1.1 Company		STMicroelectronics International N.V
1.2 PCI No.		CRP/22/13425
1.3 Title of PCI		UTAC Singapore - Qualification of Auto Packing Machine and Moisture Barrier Bag (MBB) new dimension for STM Tray Devices
1.4 Product Category		Refer to impacted product list
1.5 Issue date		2022-07-26

PCI - UTAC Singapore - Qualification of Auto Packing Machine and Moisture Barrier Bag (MBB) new dimension for STM Tray Devices

APPENDIX 4: VISUAL ILLUSTRATION OF AUTOMATED PACKING SYSTEM LAYOUT AND PROCESS

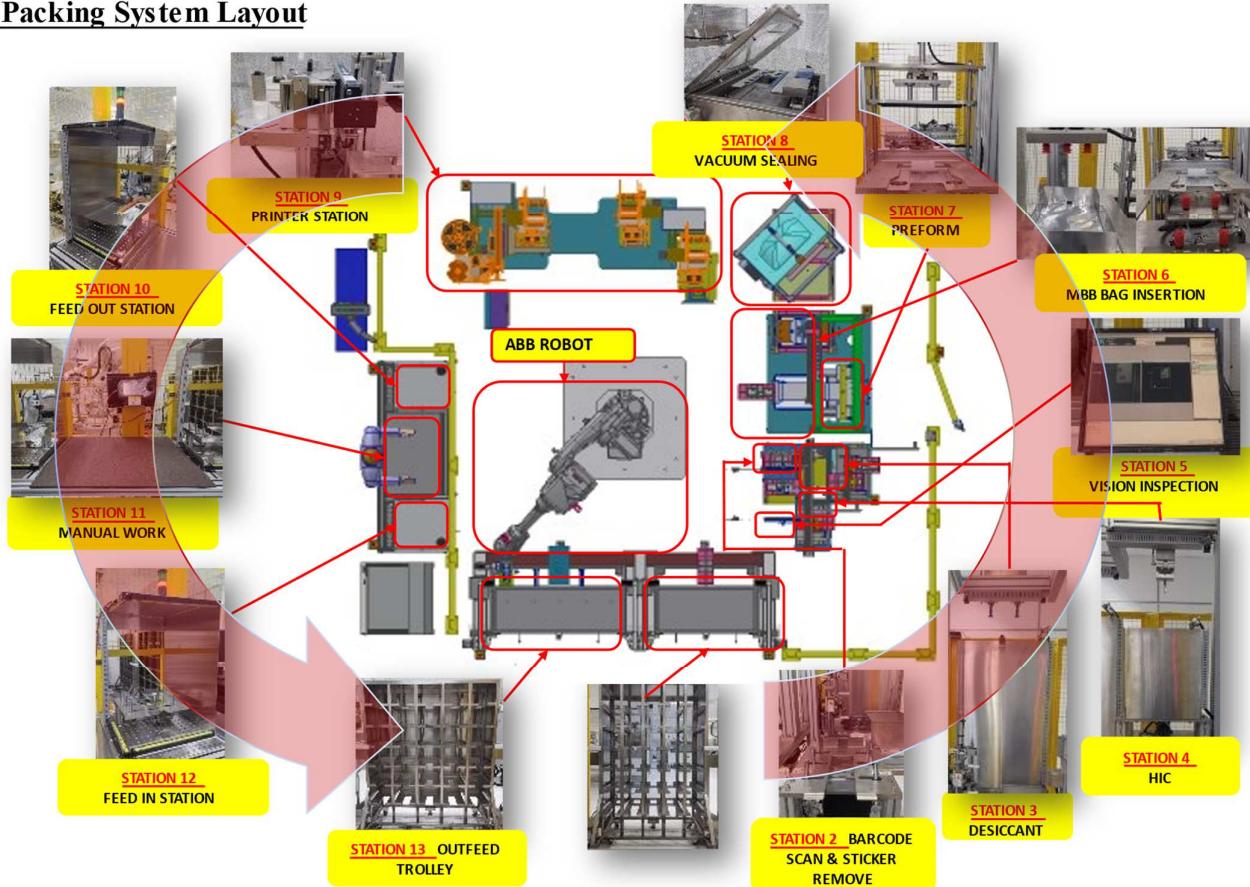
All Test FG Tray Packing out in OSAT/UTAC Singapore for all ST products (Auto/Non-Auto) is packed via automated packing using **260mm MBB Bag**
